RECEIVER TANK BRACKET IMPROVEMENT

Prevost vehicles

On the vehicles affected by this bulletin, the condenser compartment wall may present fatigue cracks on or near the A/C receiver tank support. Follow these instructions to repair and improve the support.

Figure 10: cutout dimensions

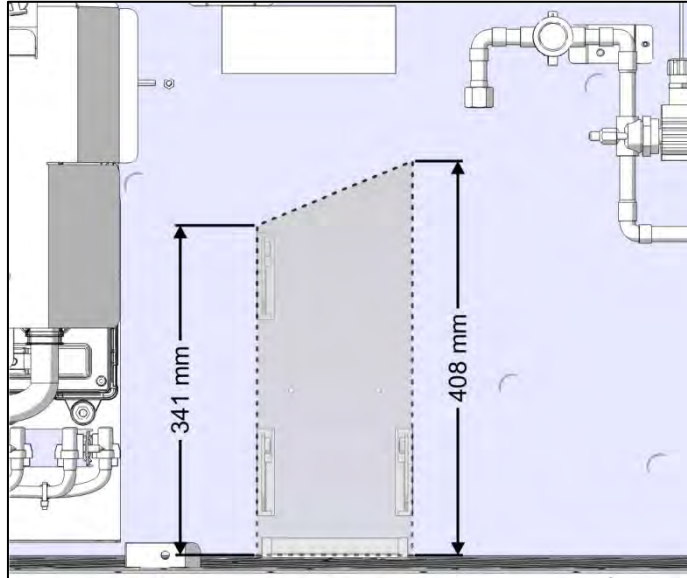
20. Clean the area of any split fuel.
21. Cut the wall at the dimensions shown, using the existing cutouts to align and locate the cutting lines. (Figure 11)

Figure 11: Crack, less than 1/4"

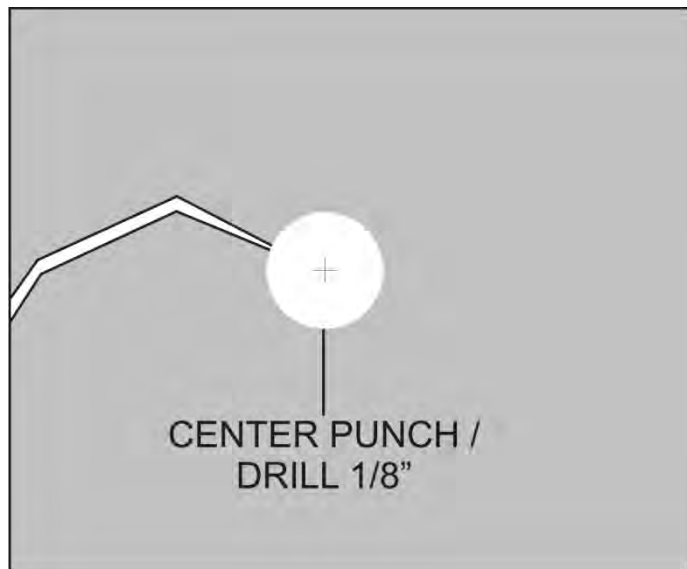
22. Locate any remaining cracks on the wall
SHORT CRACKS (LESS THAN 1/4")
23. Find the very end of the crack. Use a punch to locate precisely the relief hole.
24. Drill a 1/8" diameter relief hole. (Figure 12)

Figure 12: Removing the existing bracket

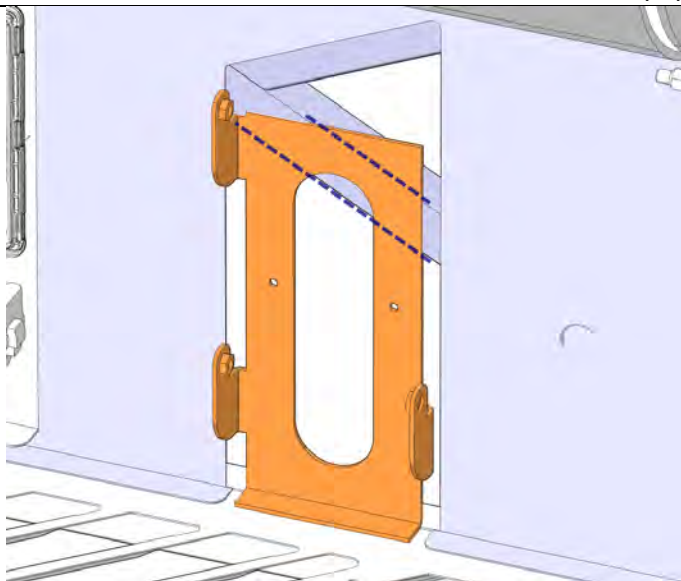
26. Cut the bracket along the dotted lines (Figure 13)
27. Remove the welds (Figure 13).
28. Grind flat any remaining welds on the tube and floor plate.

Figure 13: Refer to Appendix C

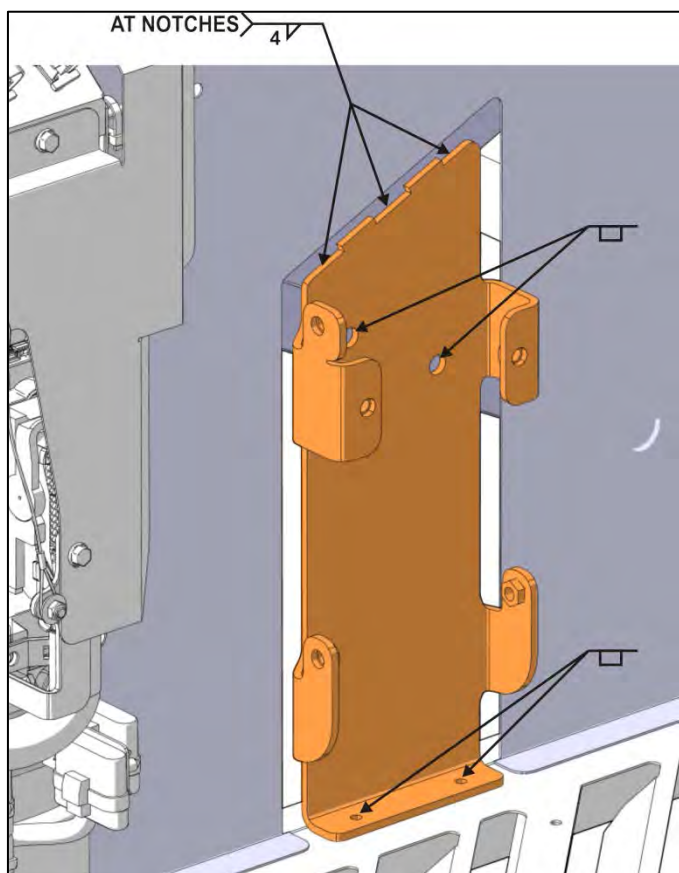
29. Weld according to specifications in Appendix C.

Figure 14: New fuel pro bracket

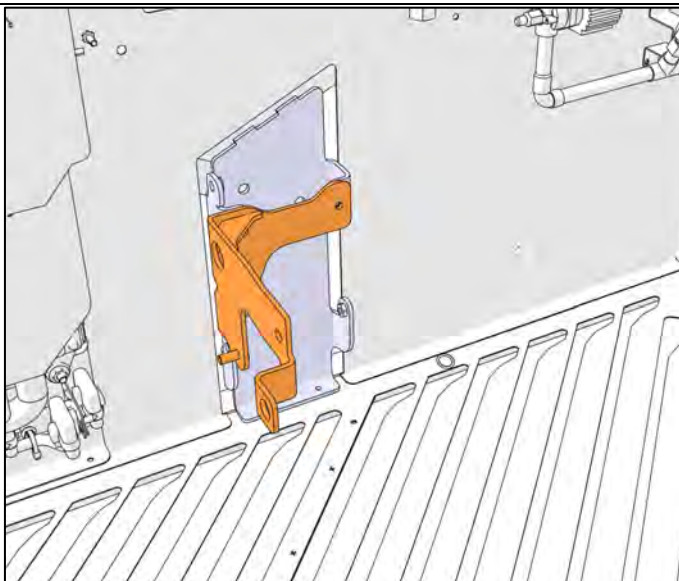
30. If a fuel pro unit was present on the vehicle, install new bracket 030018 at the same time

Tighten to 17lb-ft

Figure 21: Bracket Welding

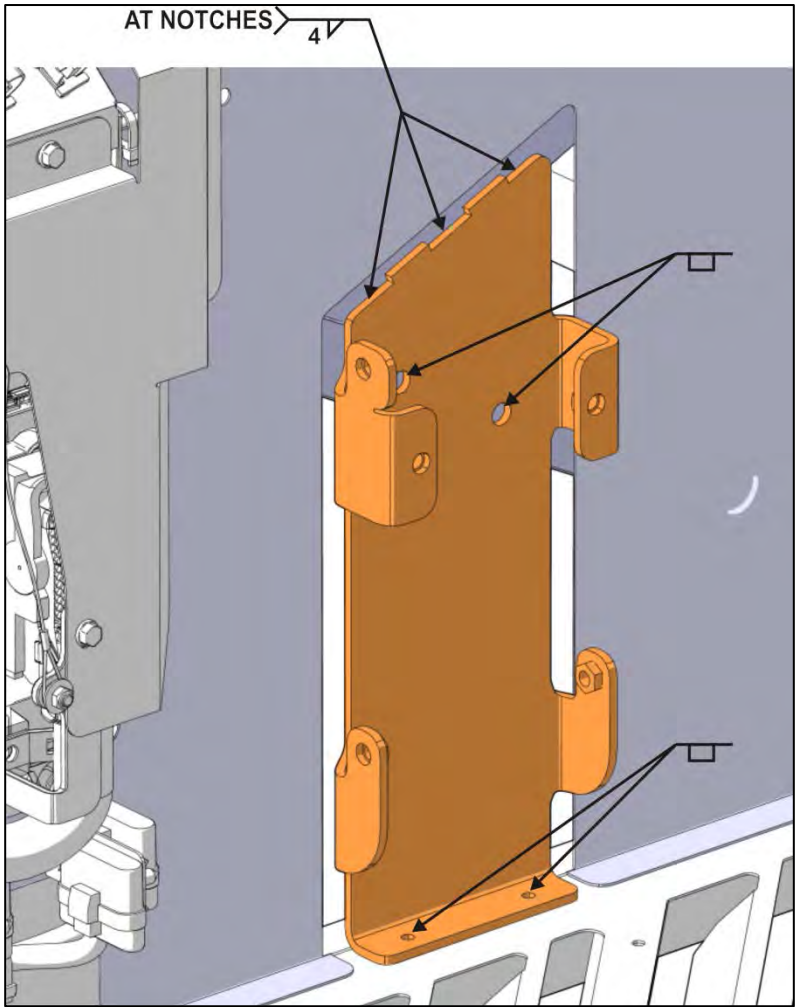
Weld support bracket to tubing behind panel by performing two plug welds and three 4mm fillet welds at the notches. Weld according to "welding parameters" above.

Volt : 19 – 22 V
Amp. : 130- 190 A
Wire speed. : 360- 500 in/min
Welding Wire: ER308 LSI 0.035 ''
Shelding Gas: 90%He- 7.5% Ar- 2.5 CO2
Welding Speed: 15- 22 in/min

Figure 22: Crack welding

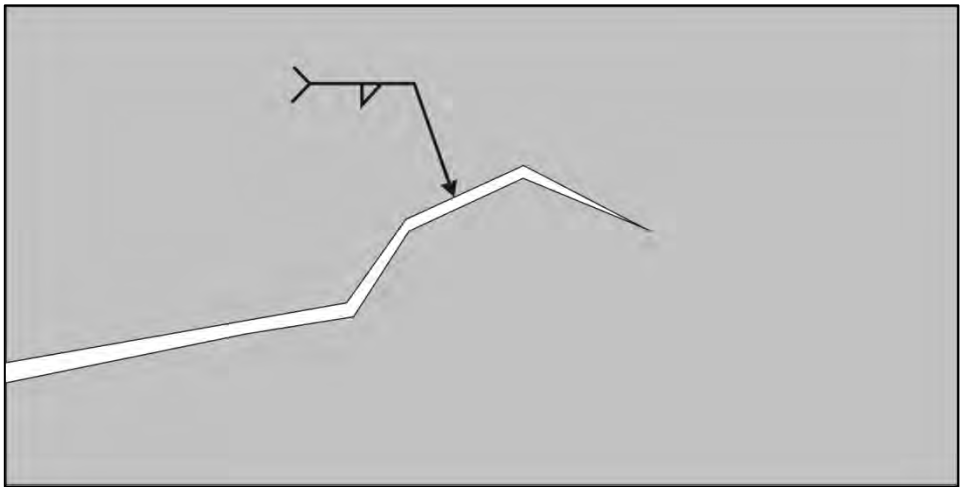
Weld cracks over 1/4" long according to "welding parameters" above.

Volt : 18.5– 21.5V
Amp. : 130- 190 A
Wire speed. : 290- 380 in/min
Welding Wire: ER308 LSI 0.035 "
Shelding Gas: 90%He- 7.5% Ar- 2.5 CO2
Welding Speed: 12- 17 in/min
